Product Change Notification

Document No **PCN-A-1030506** **Revision** **1.0**

PCN Topic: **Replace W65L110-CHS1-1 and W65L110-CHS1-2 with W65L100-OML2 and W65L100-OML2-1**

Mechanical Drawing: W65L100-OML2:

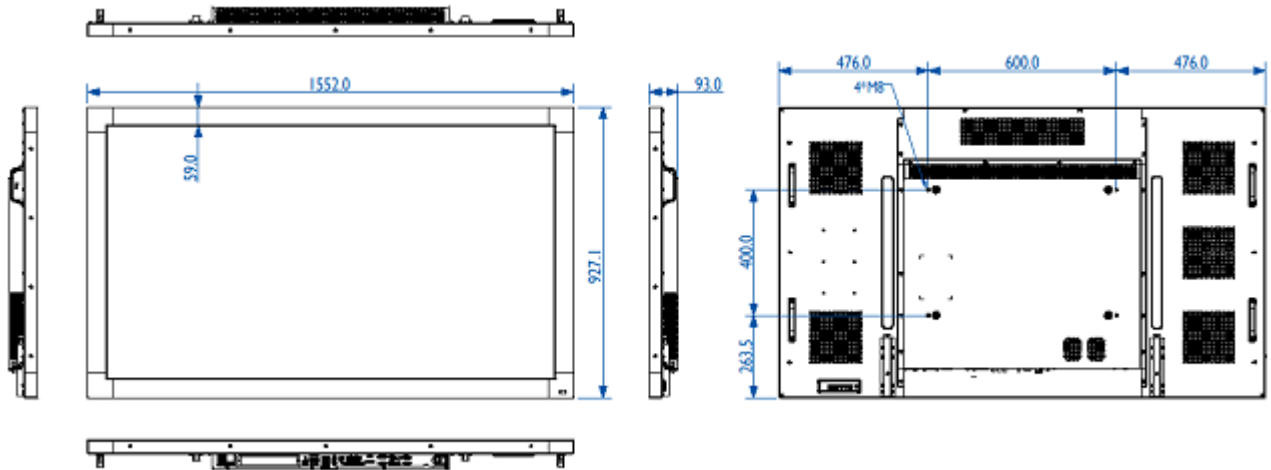
Original	NEW
	W65L110-CHS1-1/-2	W65L100-OML2/ W65L100-OML2-1
Dimensions	1560(W) x 827.2(H) x 130.8(D) mm	1552(W) x 927.1(H) x 93(D) mm 1554(W) x 929(H) x 110(D) mm(Optional IR Touch)
Contrast Ratio	5000:1	4000:1
Brightness	500	360
OPS	NO	YES
I/O	VGA,DVI	VGA, DVI, HDMI, RJ-45, Audio, RS232 and DisplayPort
Touch	IR touch (Optional)	IR Dual Points (Optional) (mechanical design is different)

I/O Comparison:
